# HORSESHOE RIDGE SUBDIVISION 1ST AMENDMENT

## SITE PLAN REVIEW

THE LEARNING EXPERIENCE

SITE PLAN REVIEW

Drawing Number: **A-2**

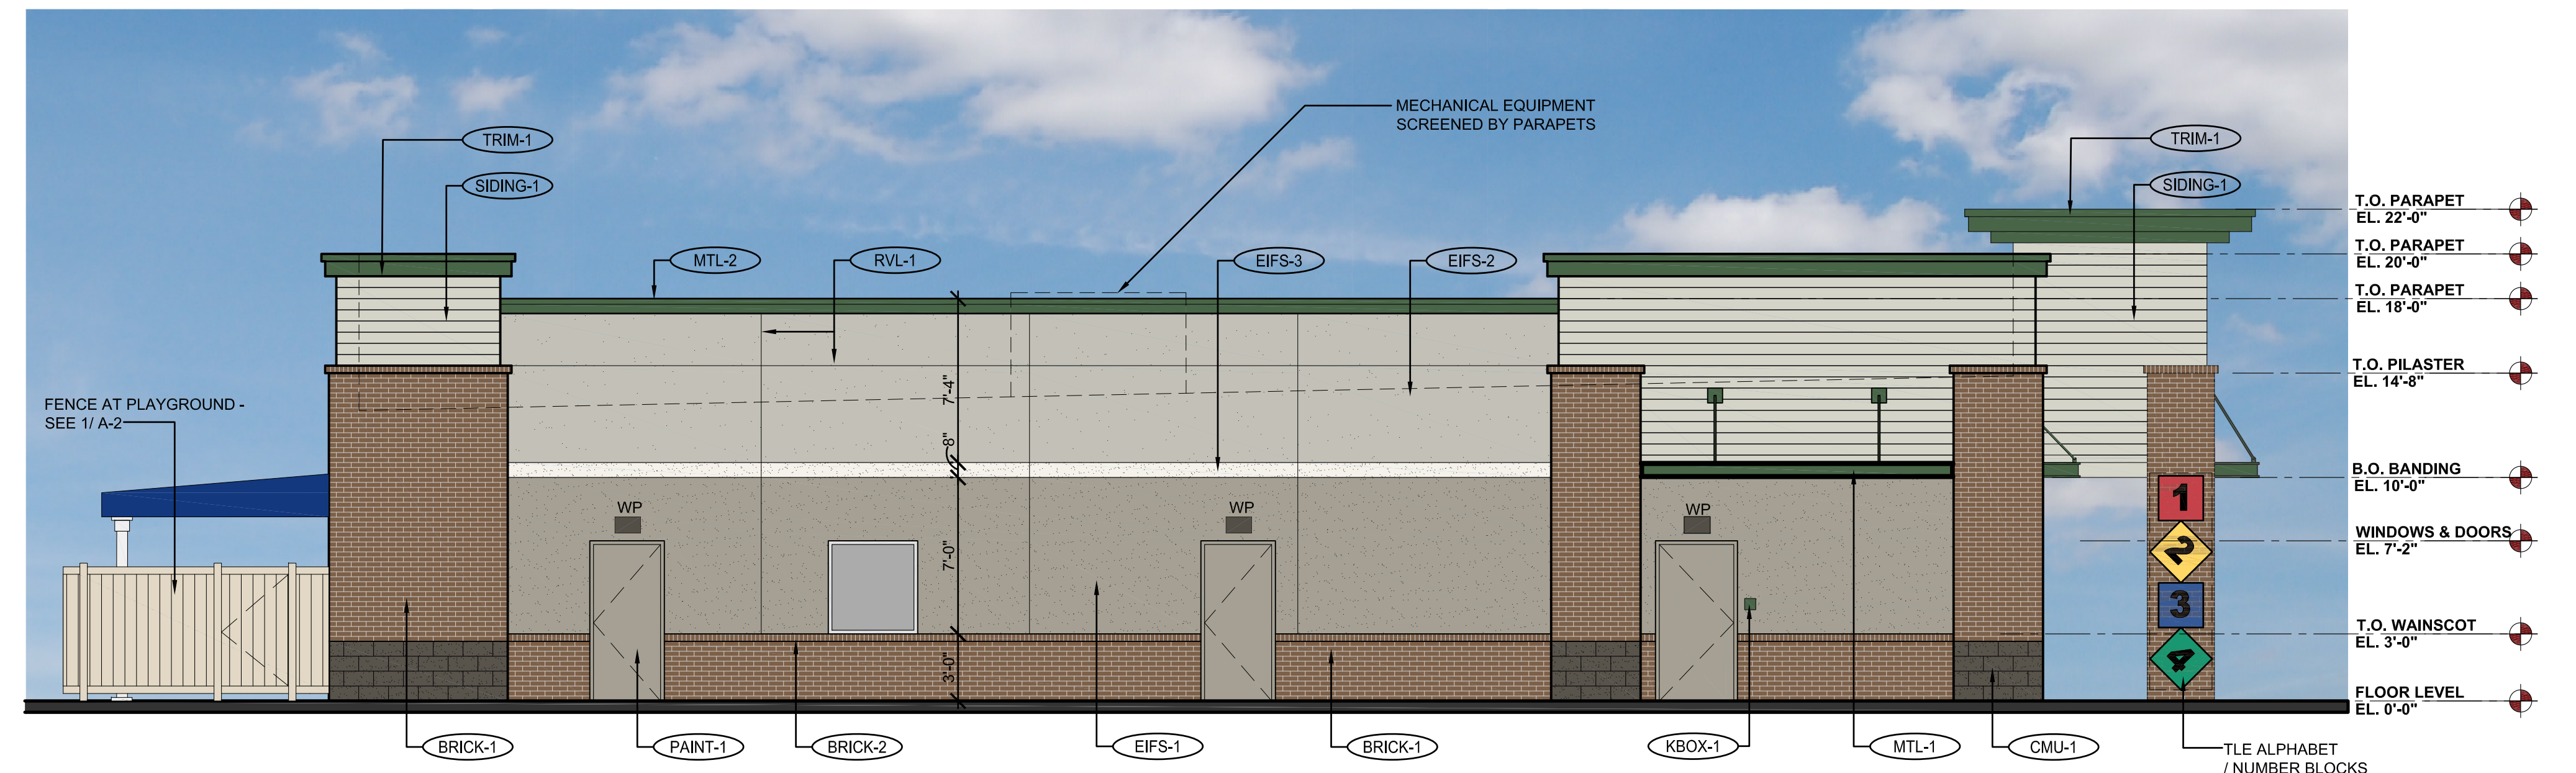
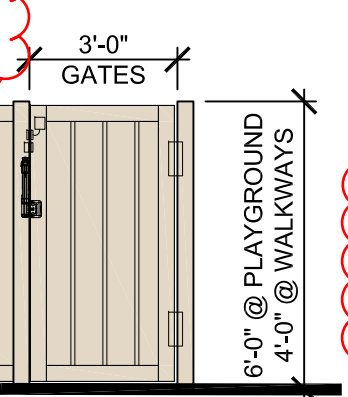
Buildings with flat roofs shall be designed to create visual interest by using variations in parapet height, articulation of cornice lines, decorative scuppers or other features. Provide a greater variation in the parapet heights to enhance the overall image of high quality and permanence on all sides.

Areas fronting the street shall be architecturally enhanced (reduce the amount of EIFS being used). This should include enhanced corners and plane projections.

Provide colored elevation of all facades that shows the proposed fence included. Building facades facing a public street must meet the architectural elements and articulation details same as the entry facade.

Material and color not included on the material board provided. Please provided material and color samples.

Add masonry columns to provide architectural feature and additionally safety feature from the children's play area.

Drawing Number: **ESP1.1**

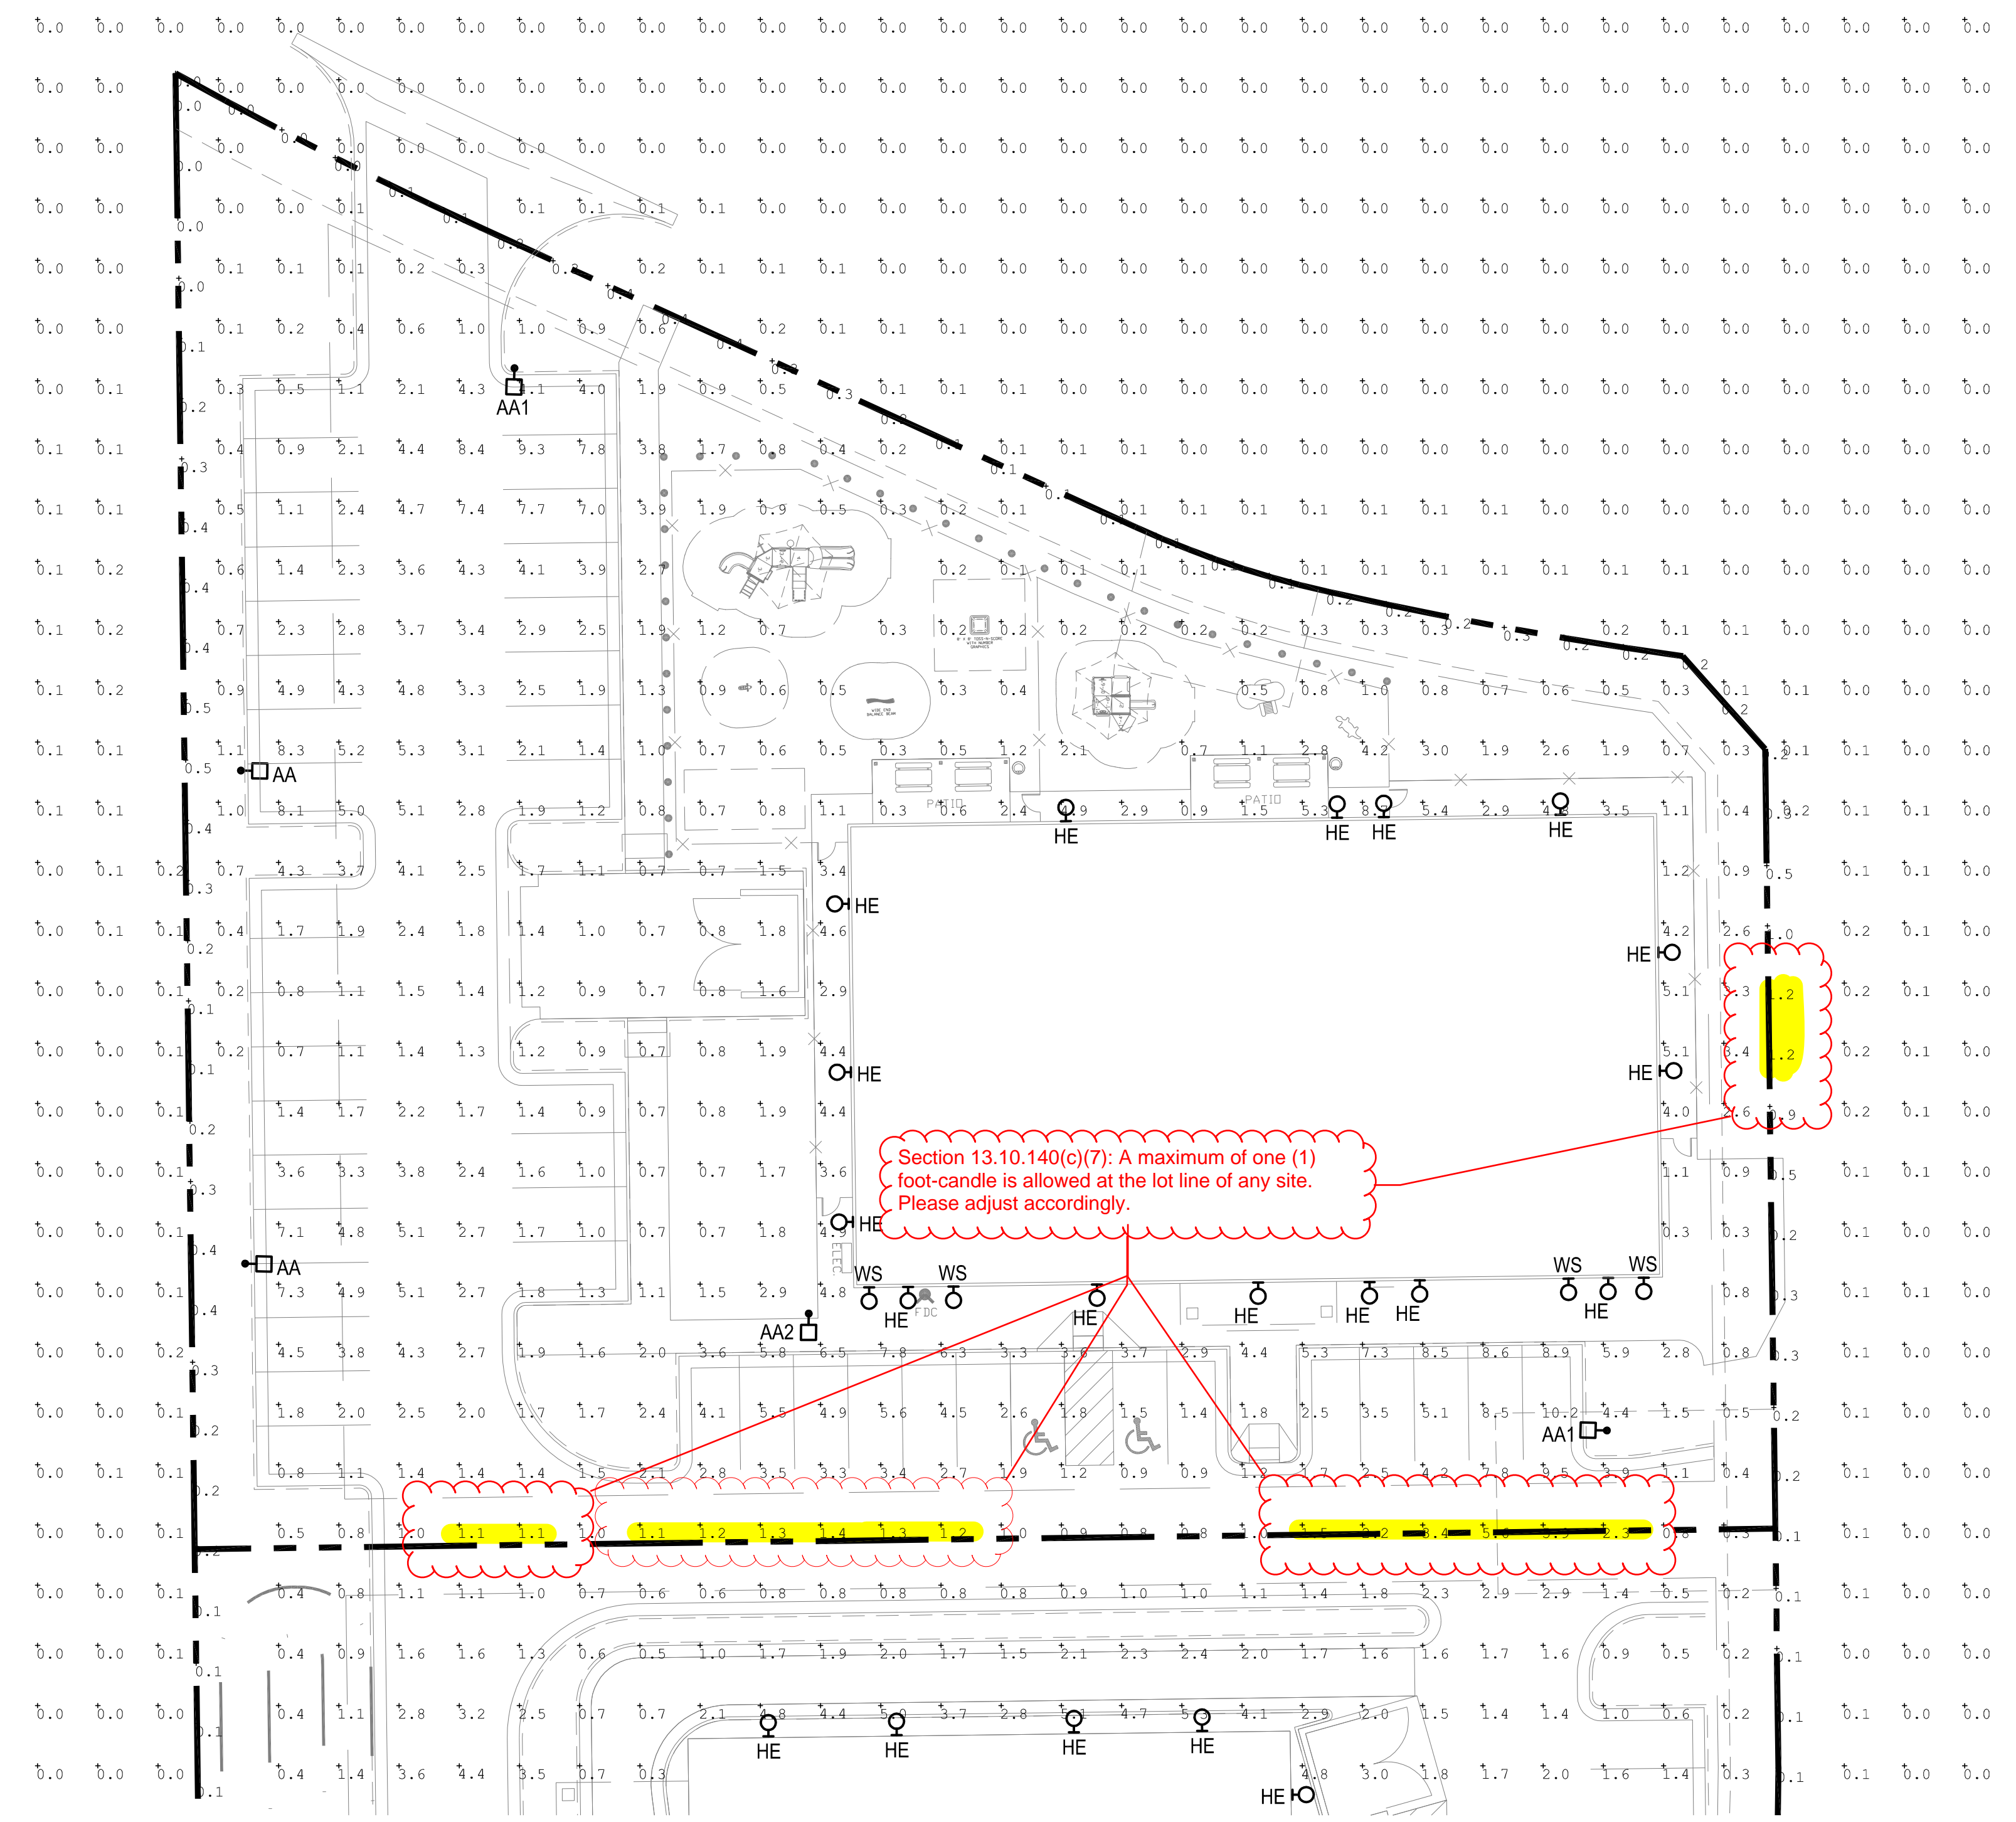
Remove the Monument Sign Lighting from the Site Luminaire Schedule if not being used on this lot or update the proposed photometric plan to include this type of lighting/symbol.

There must be a numeric value associate with the Max/Min and Avg/Min ratio.

If the ratios are zero please remove the zero values from the area and recalculate.

**TYPE 'P'**

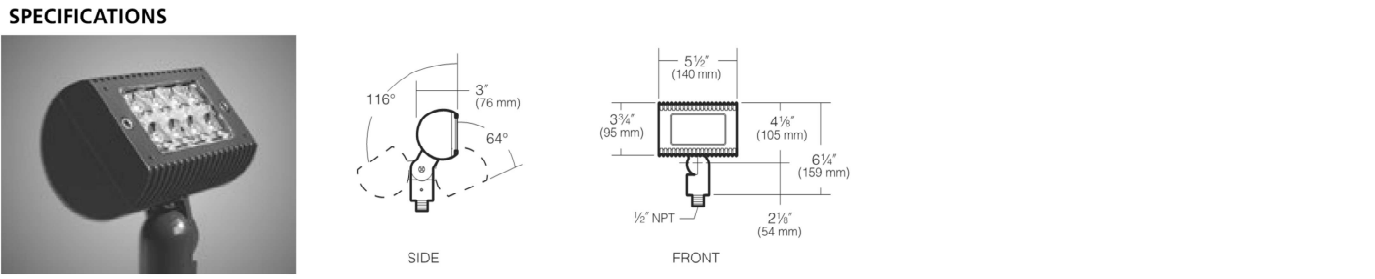
Remove the Monument Sign Lighting from the detail list if not being used on this lot or update the proposed photometric plan to include this type of lighting/symbol.
